BUILDING 7 CONTAINS 4 CONDOMIUMS WITH A TOTAL OF 15,331 SF.

BUILDING PERMIT SET FOR:

Astrid Condominiums Building 7

1 SOUTH ELEVATION - (B7) A202 1/8" = 1'-0"

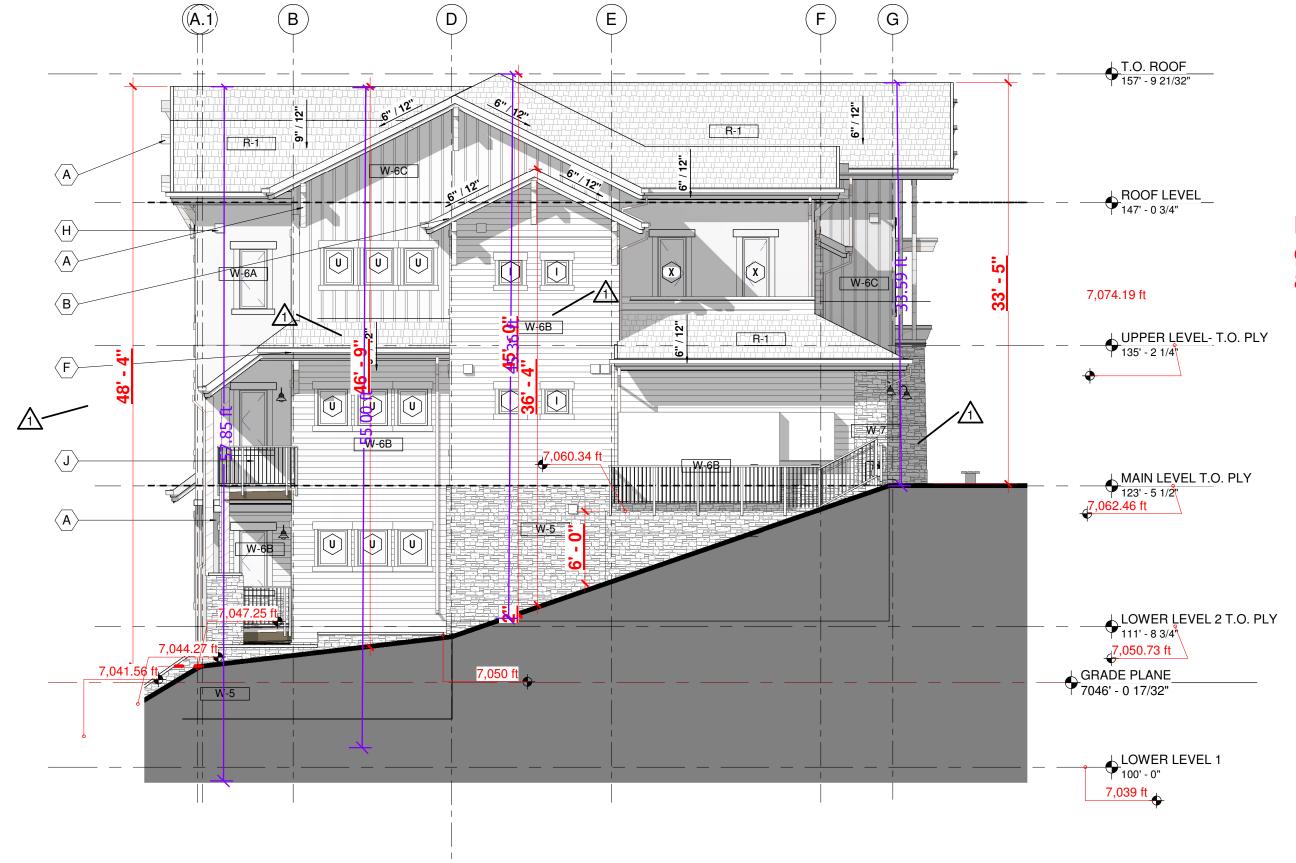
Planning: Sheet A202: South Elevation: Proposed grade and overall height appears different than that approved with PL20220662.

Planning: Sheet A202: East Elevation: Proposed grade and overall height appears different than that approved with PL20220662.
